REV.	DATE	DCN #	DRAWING TREE #
v1	JUN-29-2010	E1000234	
v2 29 MAR 2011 E1100277-V1

D1000408 aLIGO_OSUMS_INTERMEDIATE_SUPPORT_LEFT_SIDE_BRACKET, PART PDM REV: X-015, DRAWING PDM REV: X-004

VIEW C-C
 (SHOWN AFTER MATERIAL REMOVAL)

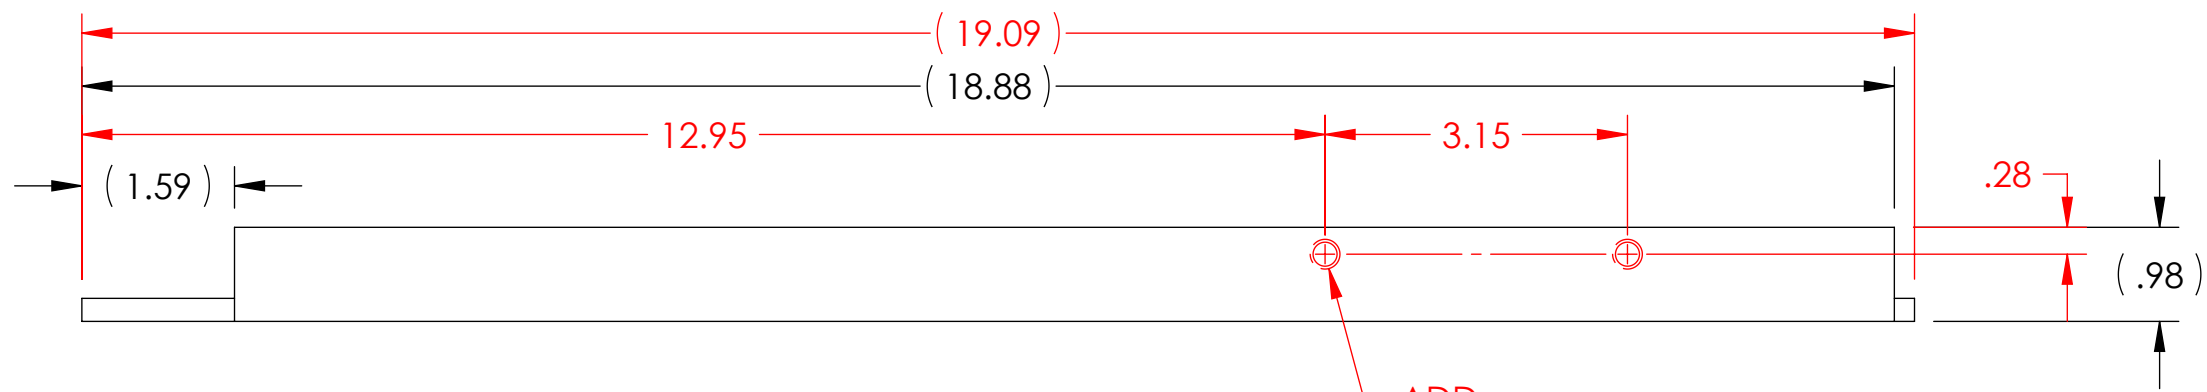
ADD
 2X TAP FOR HELI-COIL 1185-4EN-250 (1/4-20 H3) THRU 1 WALL
 ✓ 120° X Ø .35 NEAR SIDE
 INSTALLED BY LIGO
